St. Lucie Unit 1
Docket No. 50-335
Proposed Exigent License Amendment
Thermal Margin and RCS Flow Limits

ST. LUCIE UNIT 1 MARKED-UP TECHNICAL SPECIFICATION PAGES

FIGURE 2.1-1 REACTOR CORE THERMAL MARGIN SAFETY LIMIT - FOUR REACTOR COOLING PUMPS OPERATING

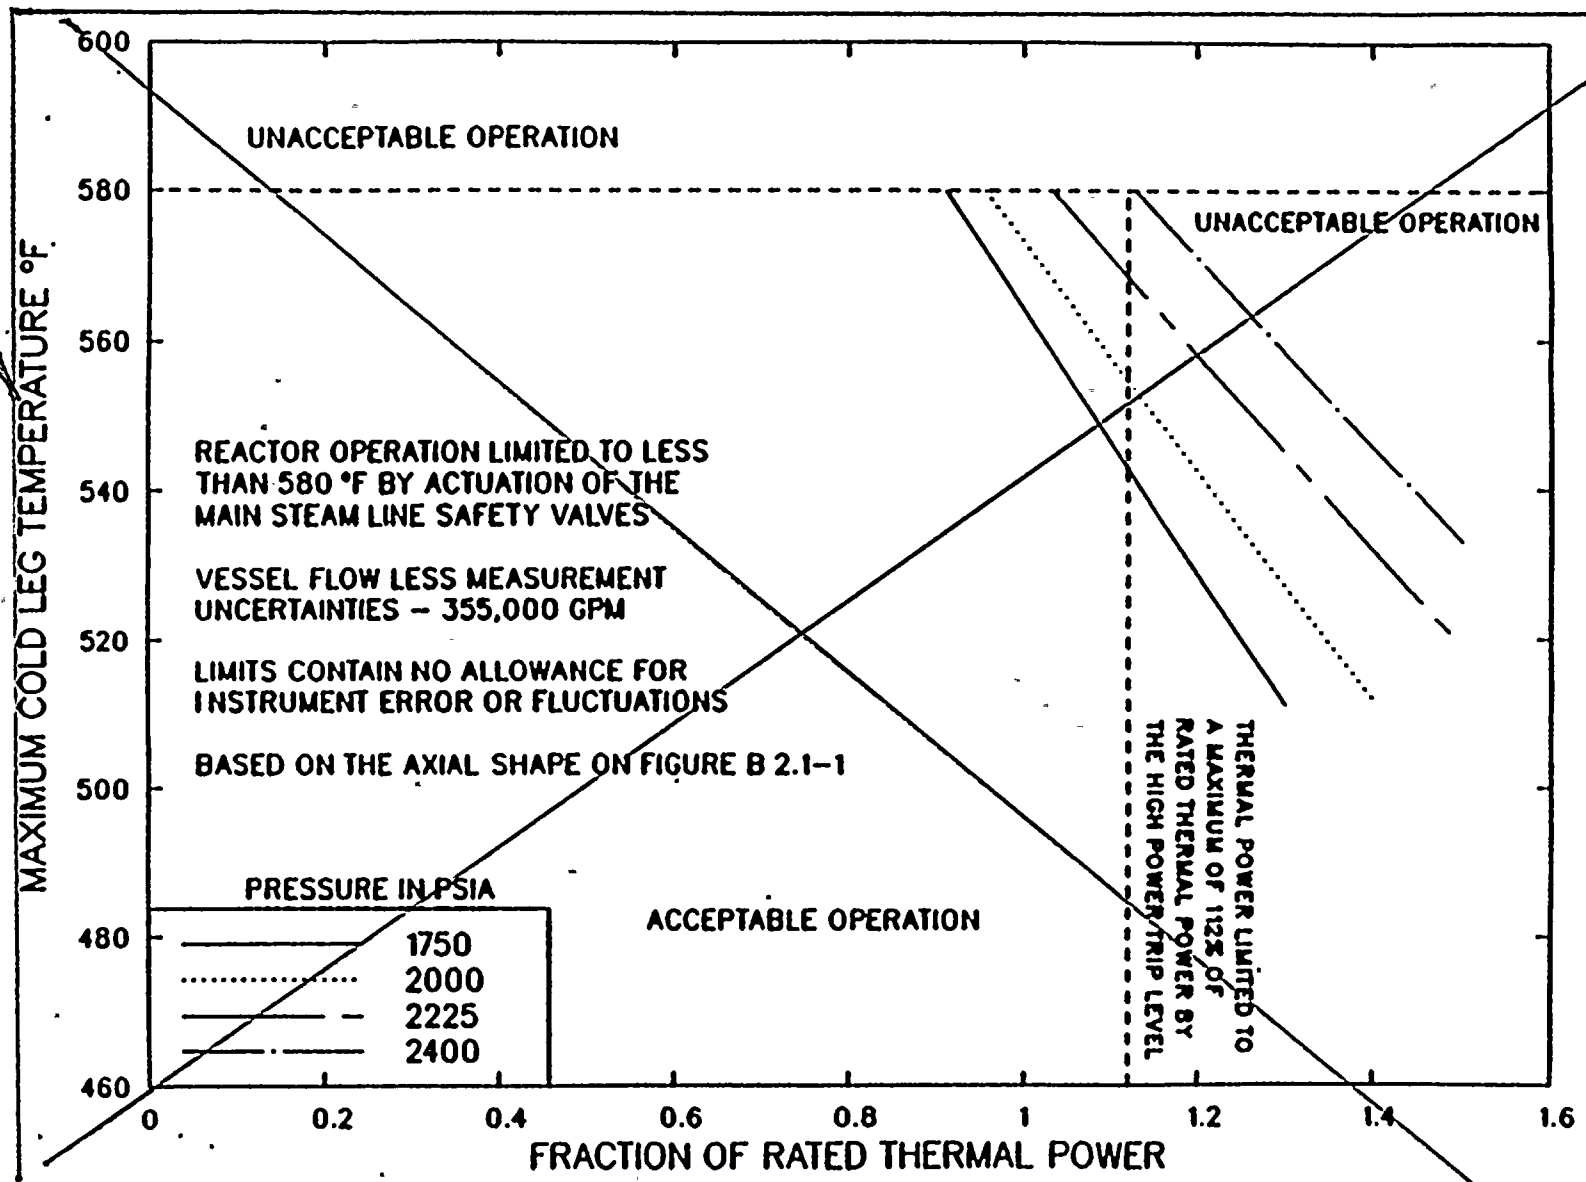
REPLACE WITH REVISED FIG. 2.1-1 (NEXT PAGE).

Revised Figure 2.1-1

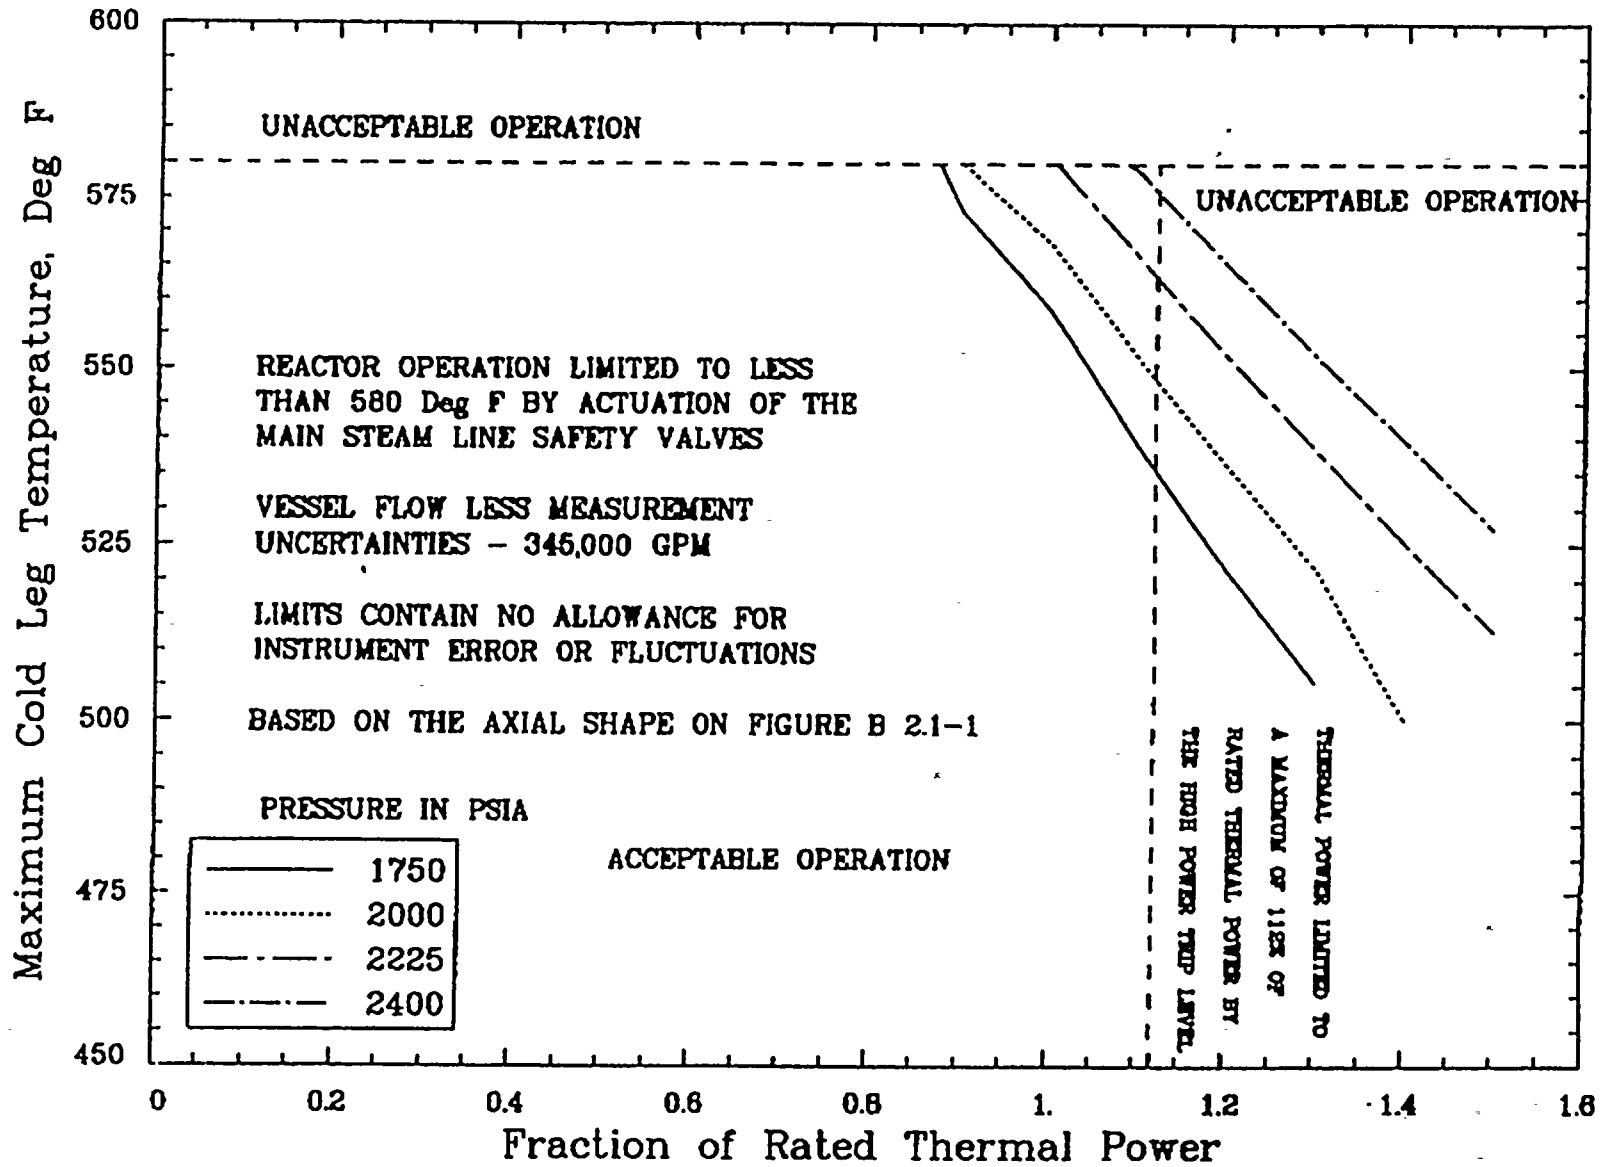
FIG. 2-1-1 (NEXT PAGE)
WITH REVISED
& REVISION
